UNITED STATES PATENT AND TRADEMARK OFFICE

| APPLICATION NO. | FILING DATE | FIRST NAMED INVENTOR | ATTORNEY DOCKET NO. | CONFIRMATION NO. |
|-----------------|-------------|----------------------|---------------------|------------------|
| 10/009,696 | 11/06/2001 | John Eric Arnold | DN1999111USA | 1392 |

|  Office Action Summary | Application No. 10/009,696 | Applicant(s) ARNOLD ET AL. | |

FIG. 4

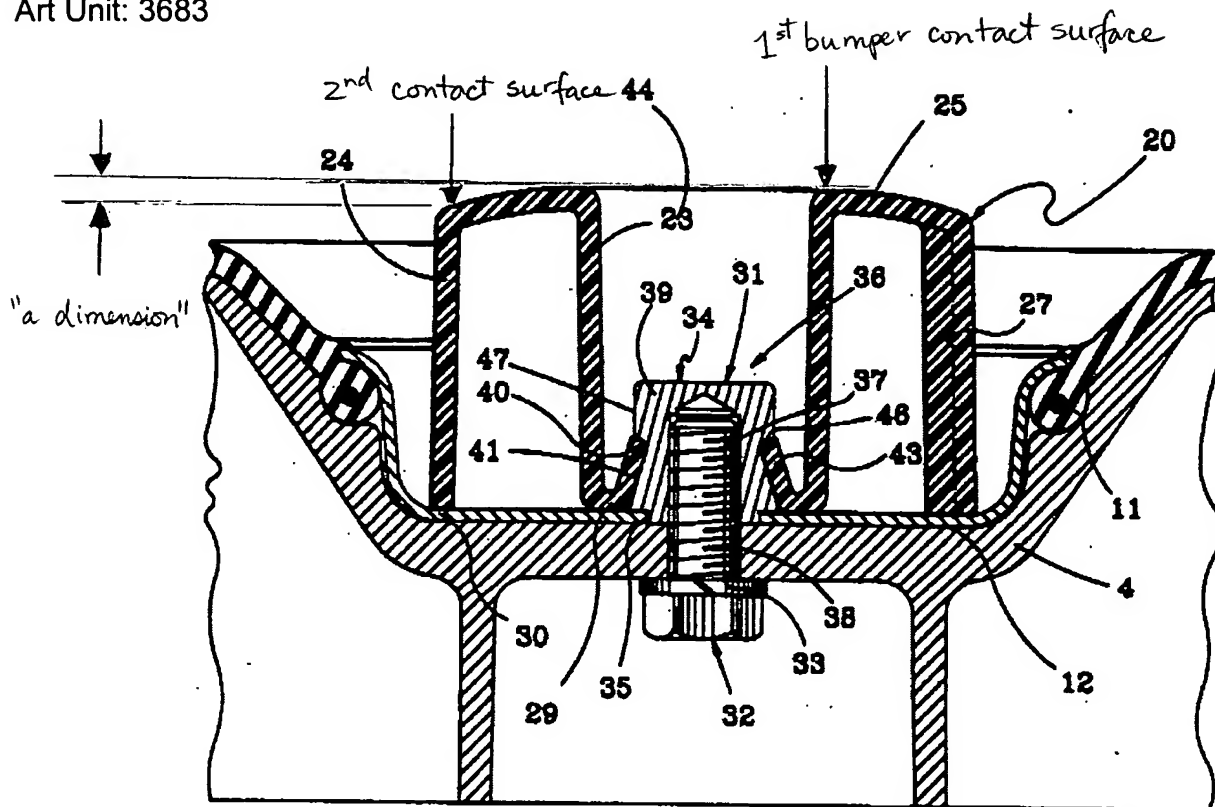
Re: claims 2, 3 and 4, Ecktmann shows support ribs 43, 26, 27, 29, 30 wherein said ribs are substantially radially extending; and are a series of concentrically disposed.

Re: claim 5, Ecktmann shows the first contact surface to be closer to the center corresponds to rib 29, the second contact surface to be further out corresponds to rib 30 and are separated by a dimension, please see the marked up figure above.

Re: claim 18, Ecktmann shows the axially outer surface to be closer to the center corresponds to rib 29, the second axially outer surface to be further out corresponds to rib 30 and are separated by a dimension, see marked up figure above.
